HISTORIC AND DESIGN REVIEW COMMISSION

HDRC CASE NO: 2021-057
ADDRESS: 1235 E CROCKETT ST
LEGAL DESCRIPTION: NCB 1373 BLK 1 LOT S 125 FT OF 27
ZONING: RM-4, H
CITY COUNCIL DIST.: 2
DISTRICT: Dignowity Hill Historic District
APPLICANT: Kali Tripp/Tripp Flip, LLC
OWNER: Kali Tripp/Tripp Flip, LLC
TYPE OF WORK: Removal of an existing front door
APPLICATION RECEIVED: January 27, 2021
60-DAY REVIEW: Not applicable due to City Council Emergency Orders
CASE MANAGER: Edward Hall

REQUEST:

EXTERIOR ELEVATIONS

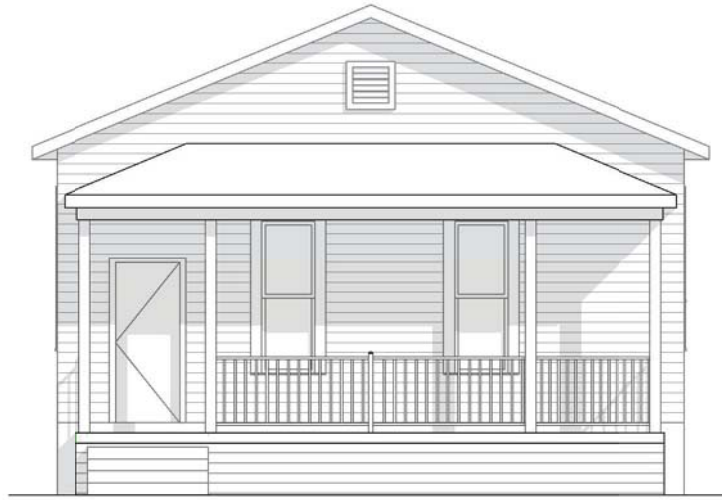
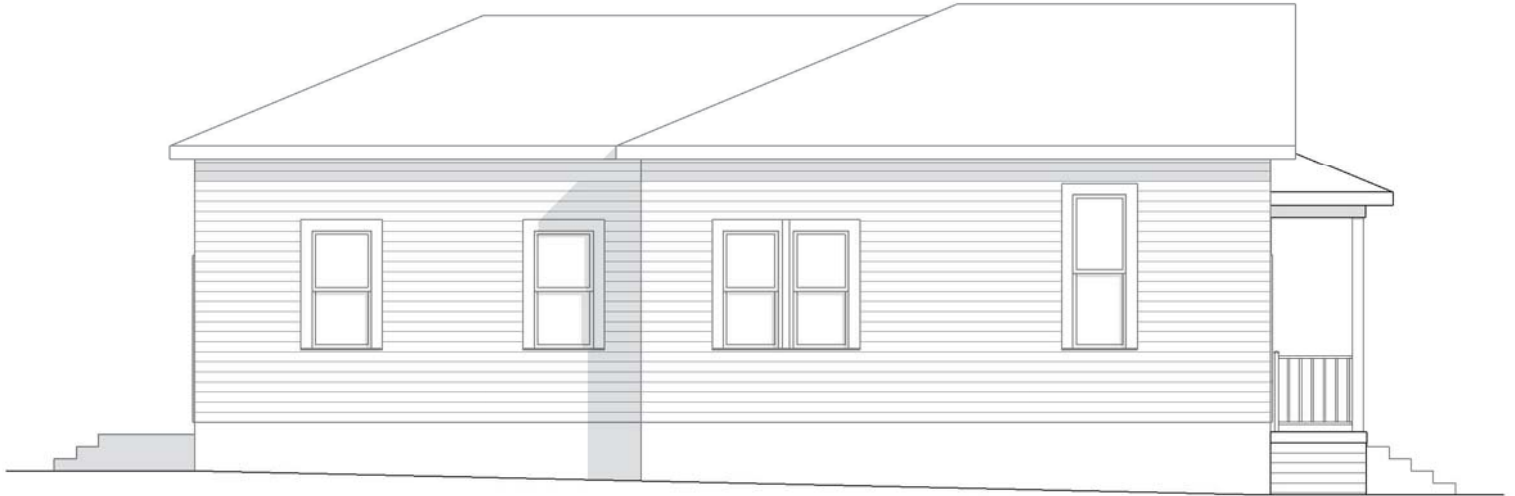
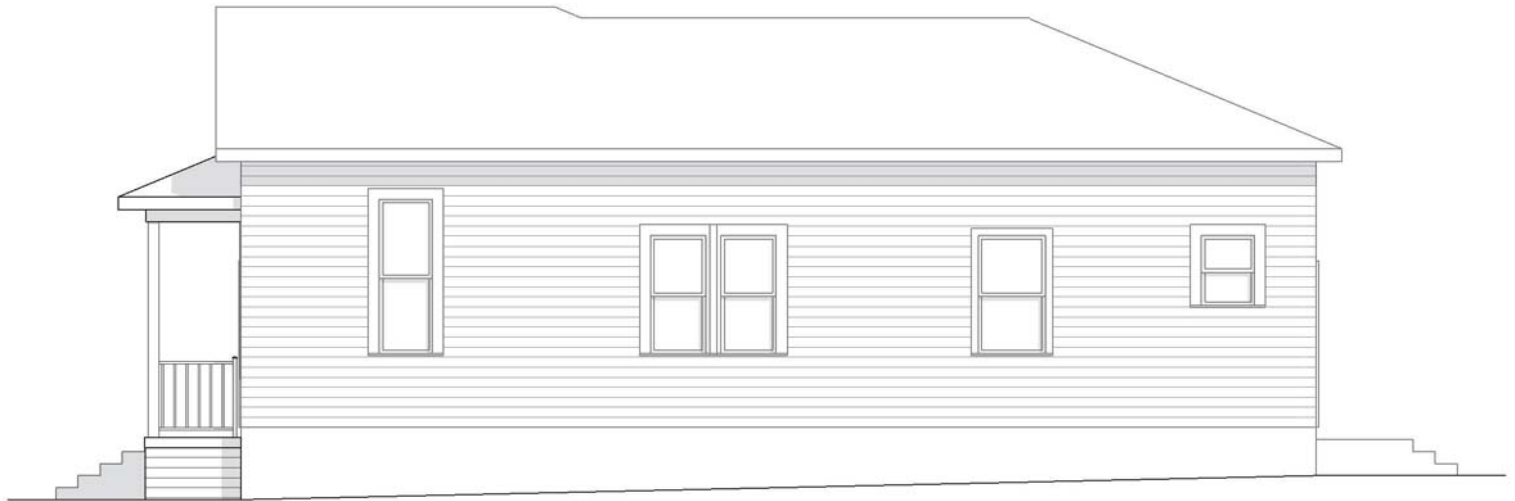
- c. DOOR REMOVAL – The Historic Design Guidelines note that original window and door locations should be preserved as they exist. Staff has not found sufficient evidence that alludes to the historic structure having not been a duplex. Staff finds that maintaining both front doors provides an architectural reference to the structure’s historic form.

Staff does not recommend approval of the proposed door removal based on findings b and c.
